ADDENDUM
to
AMENDMENT TO MDDP
for
COTTAGES AT WOODMEN HEIGHTS
and
FINAL DRAINAGE REPORT
for
COTTAGES AT WOODMEN HEIGHTS FILINGS NO. 1 & 2

Project #: 21369-00CSCV

SUMMARY OF ADDENDUM CHANGES TO APPROVED AMENDMENT TO MDDP

Storm Sewer Profile

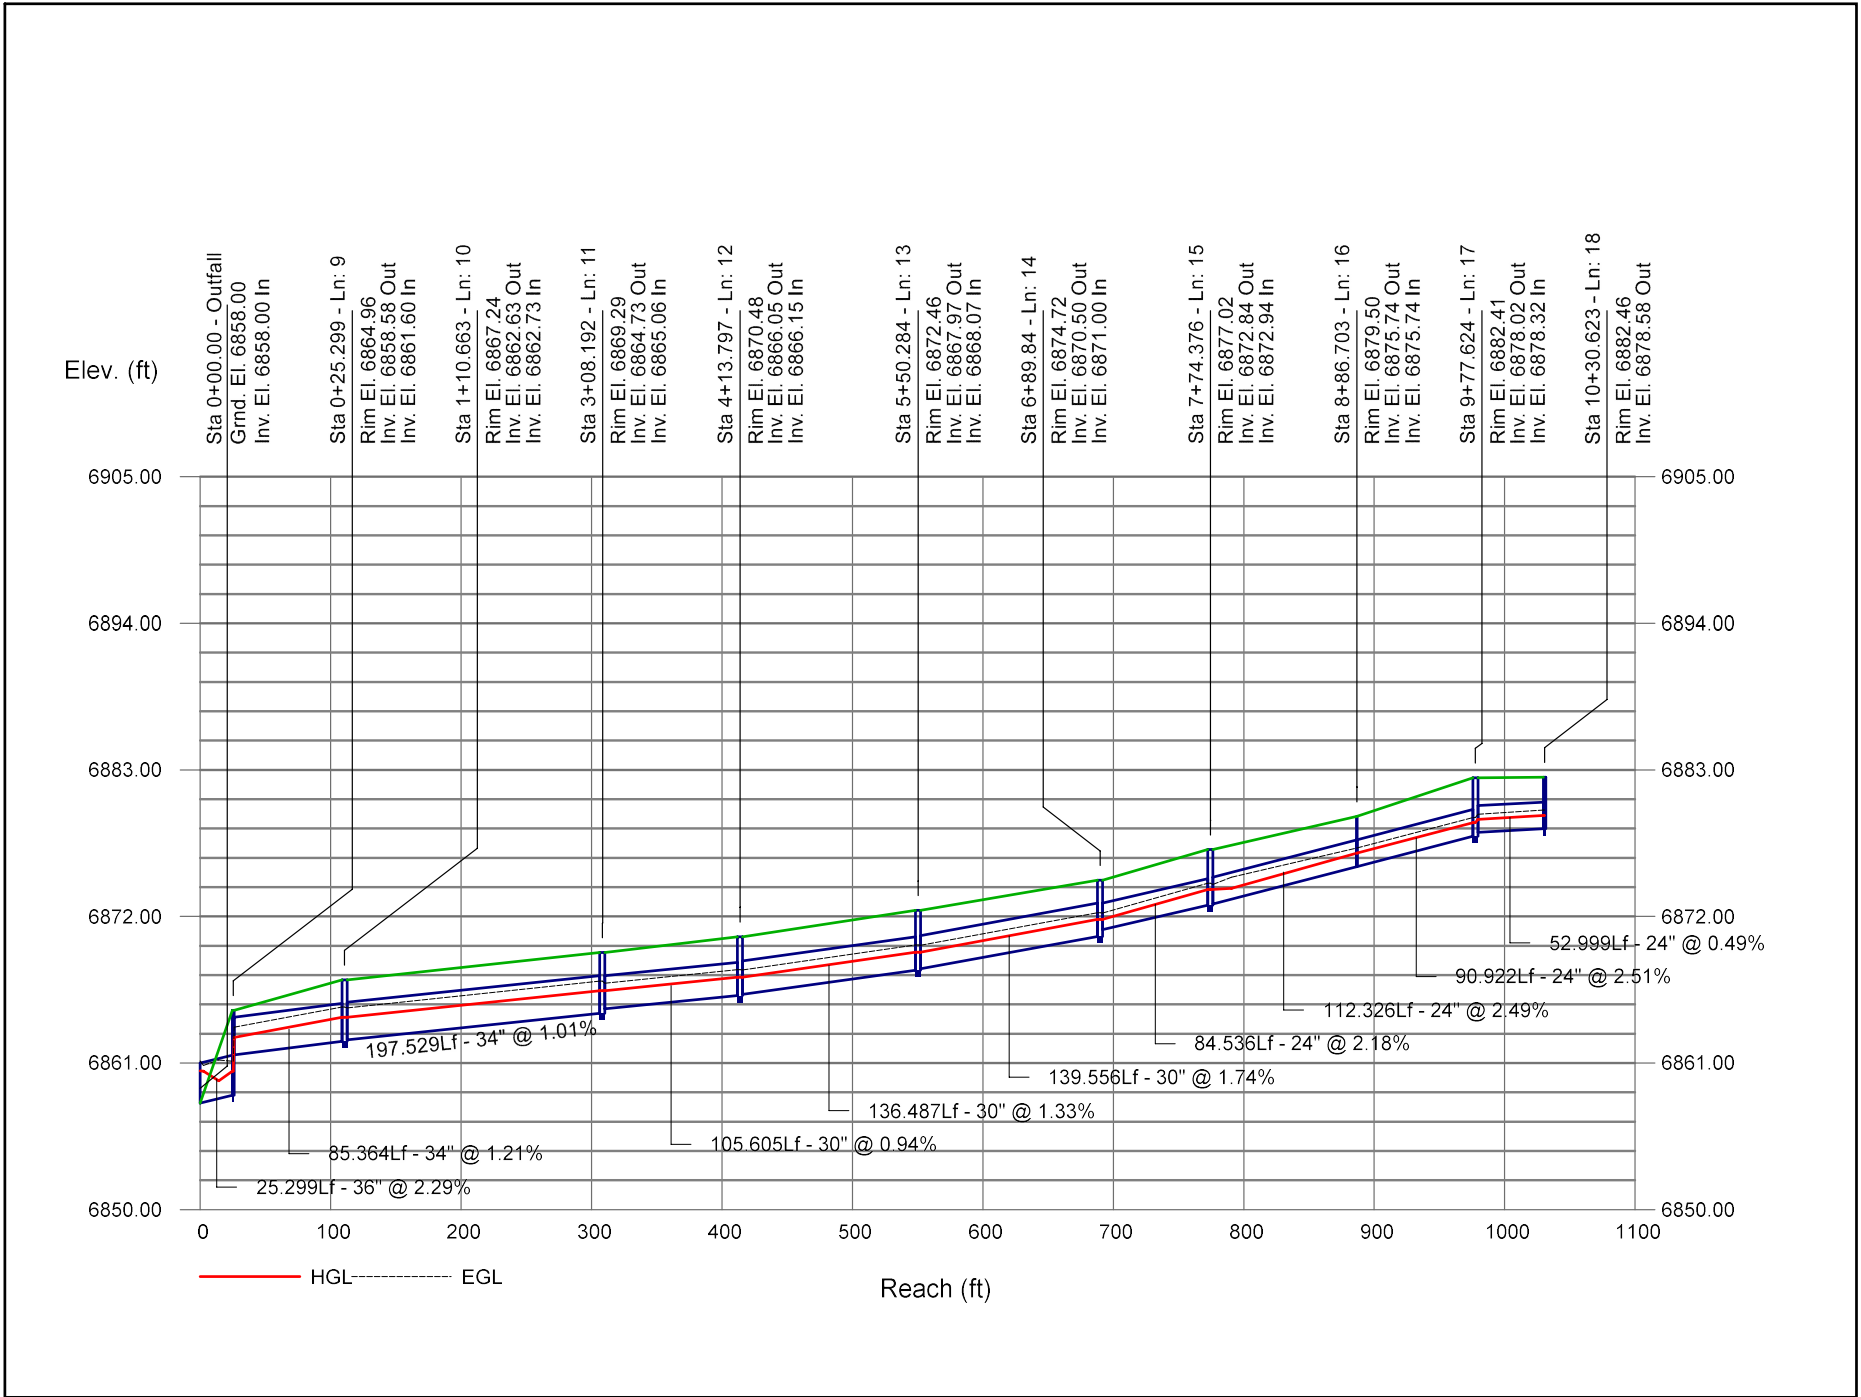
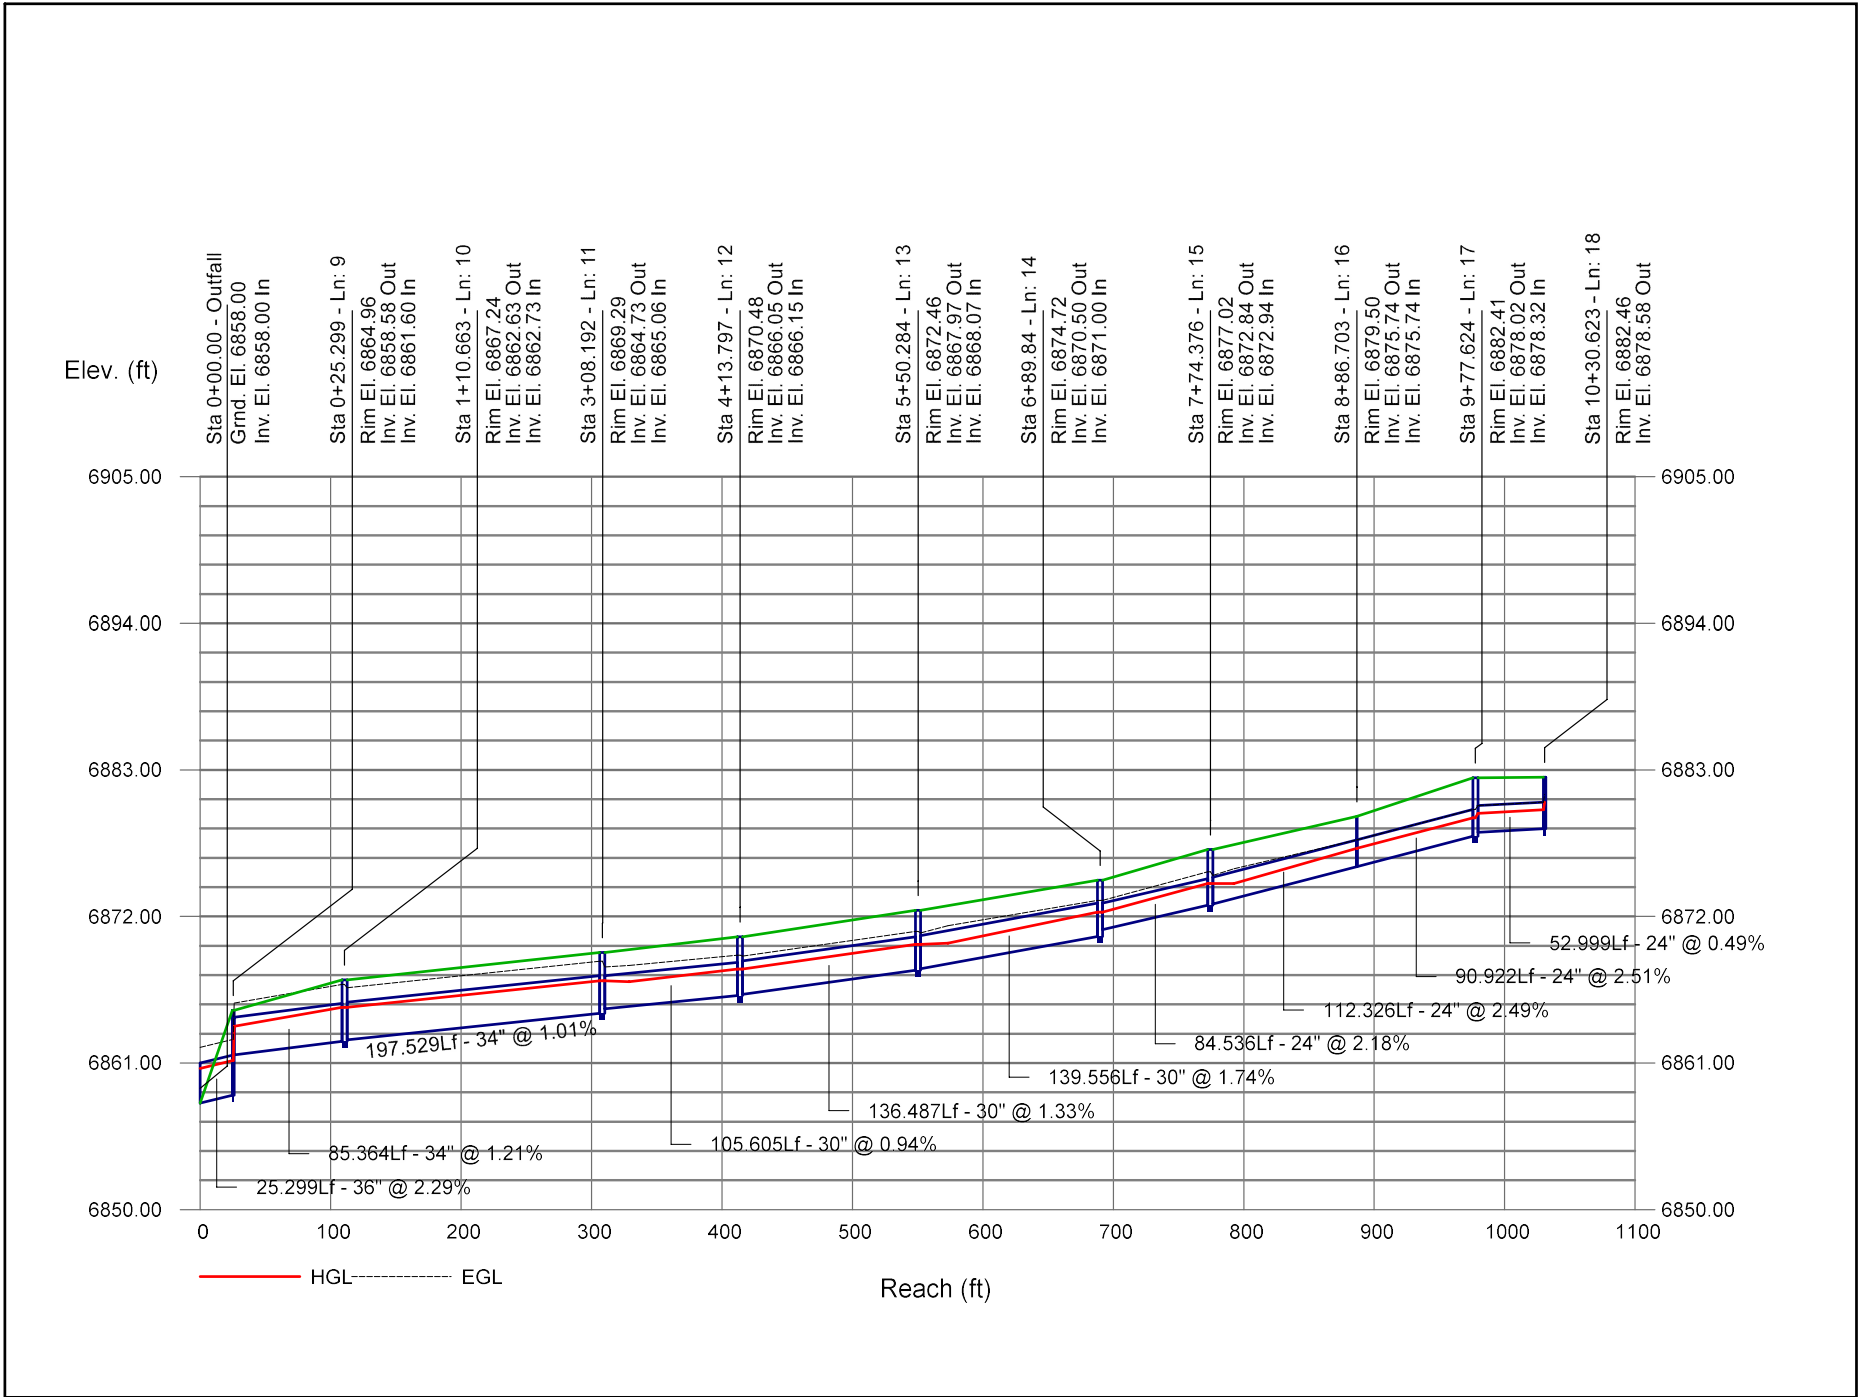
The Amendment to the MDDP for Cottages at Woodmen Heights and Final Drainage Report for Cottages at Woodmen Heights Filings No. 1 & 2 was approved on 5/20/22. This addendum to the drainage report is to show a change to the HGL calculations for the proposed storm system. The inverts of the storm pipe changed slightly, as well as pipe slopes. These changes did not affect the HGL's and the HGL's are still within the acceptable parameters. These changes will not adversely affect downstream or surrounding developments. Please find updated HGL calculations in the Appendix.
